RE: REVISED DRAINAGE PLAN FOR RIO GRANDE ZOO RESTROOM FACILITY
(K-13/D26) ARCHITECT'S STAMP DATED JANUARY 23, 1989

**SAFARI JUNCTION
 RESTROOM FACILITY
 RIO GRANDE ZOOLOGICAL PARK
 ALBUQUERQUE, NEW MEXICO**

**ARCHITECTURAL &
 UTILITIES SITE PLAN**

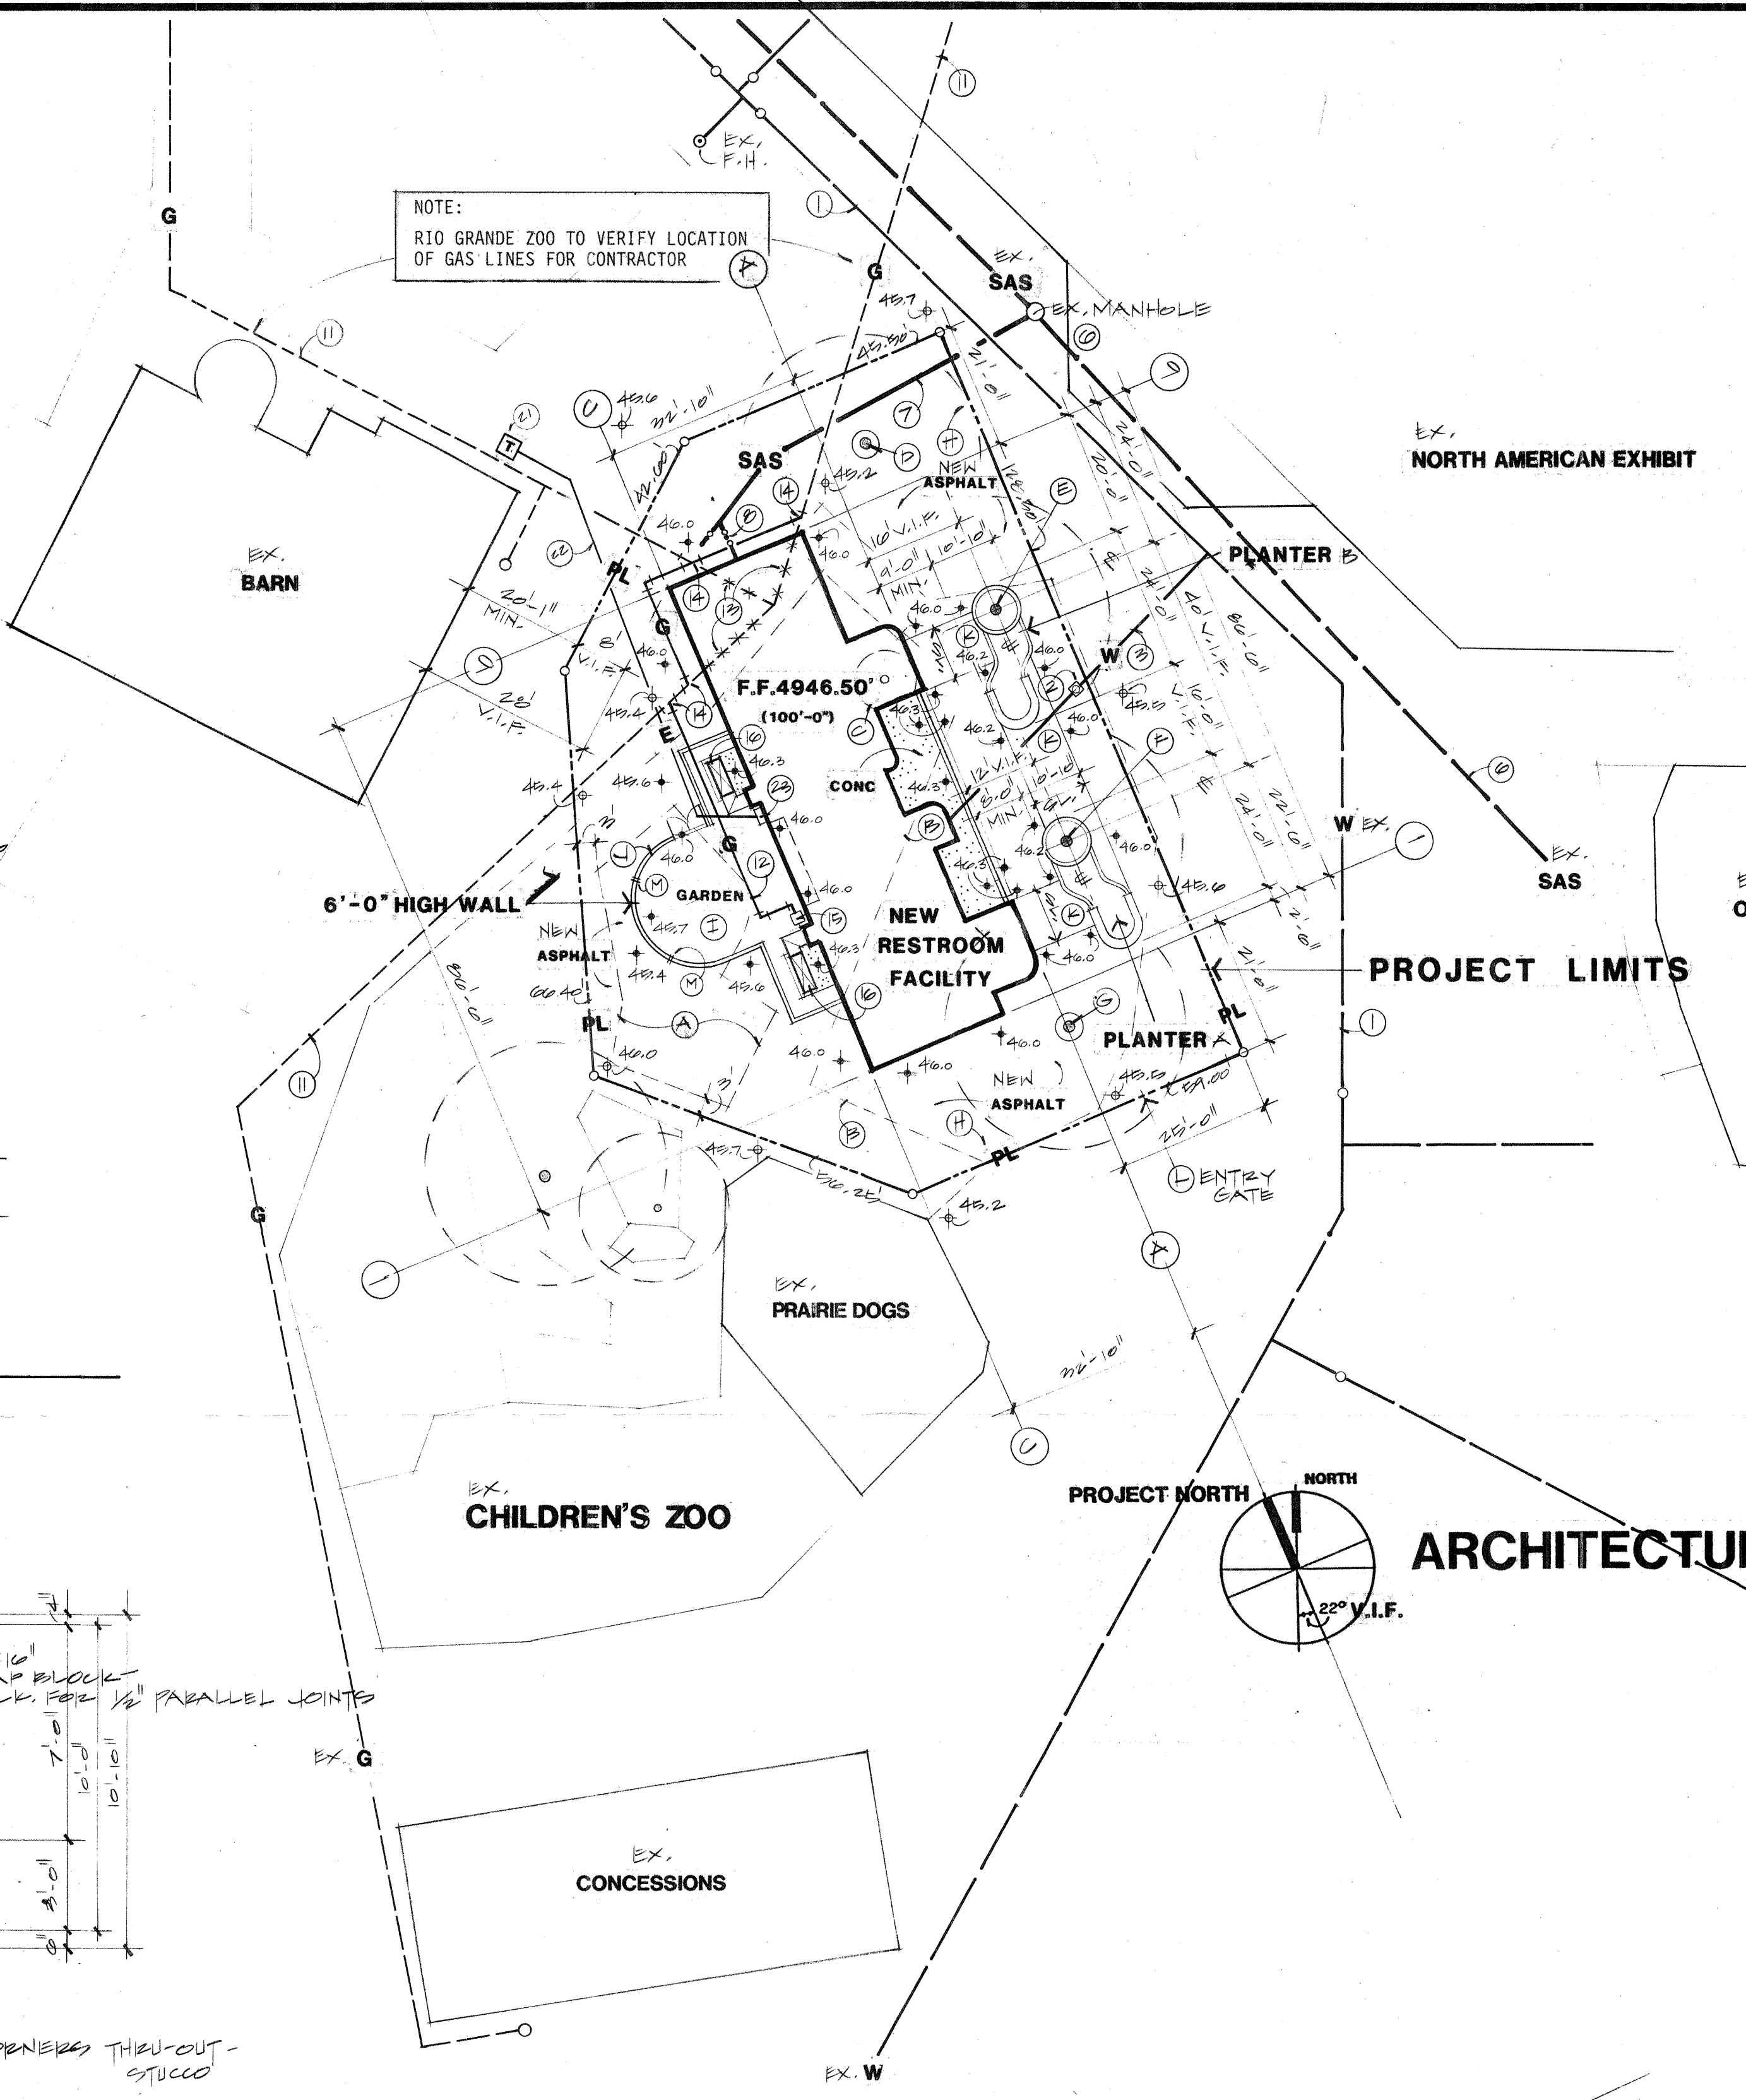
Based on the information provided on your resubmittal of April 19, 1989,
the above referenced plan is approved for Building Permit.

Please attach a copy of this plan to the construction sets prior to
sign-off by Hydrology.
